Safety Recall Notice

Some **GT** bicycles were sold equipped with disc brakes and a front quick release lever that can come into contact with the front disc brake when improperly adjusted or left open while riding. An example of a bicycle with a front quick-release cam lever that is able to be opened far enough to create this potential contact is shown in Figure 1 below. An example of a bicycle with a front quick-release cam lever that does not have the potential for contact with the disc brake is shown in Figure 2. When a quick release like the one shown in Figure 1 is improperly adjusted or left open on a bicycle which also has a front disc brake, the quick release lever can become caught in the front disc brake assembly. If this happens, the front wheel could separate or come to a sudden stop and the rider could lose control of the bicycle posing a serious risk of injury.

Figure 1. Quick-release lever with potential for contact Figure 2. Quick-release lever with adequate clearance

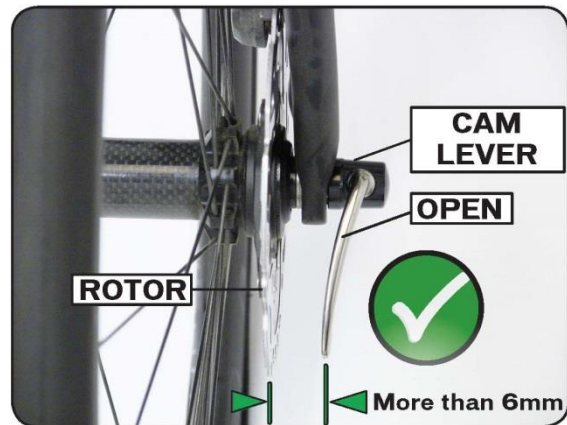
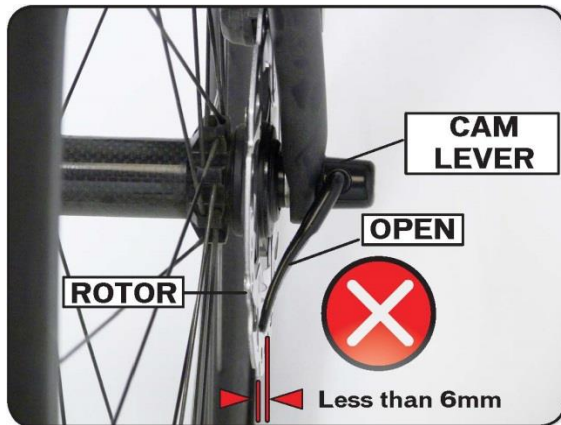
AFFECTED MODELS: Any **GT** bicycle equipped with disc brakes and a front quick release lever that can contact the disc brake assembly when fully opened is subject to this recall. Bicycles with front quick-release cam levers that have a clearance of at least 6 millimeters, which is the width of a #2 pencil, between the edge of the lever in its most open position and the disc brake rotor are not considered affected models. If you can pass a #2 pencil between a fully opened quick release lever and your bike's disc brake rotor, your bike is not an affected model. For a video demonstration of how to check this, please visit www.quickreleaserecall.com.

WHAT GT WILL DO FOR OWNERS OF A RECALLED BICYCLE: If you own a bicycle that is subject to this recall, **GT** will provide you—through your **GT** retailer—a free replacement quick release, including free installation. Please see your local **GT** retailer or contact **GT** with questions at **800 – 843 -2453**.
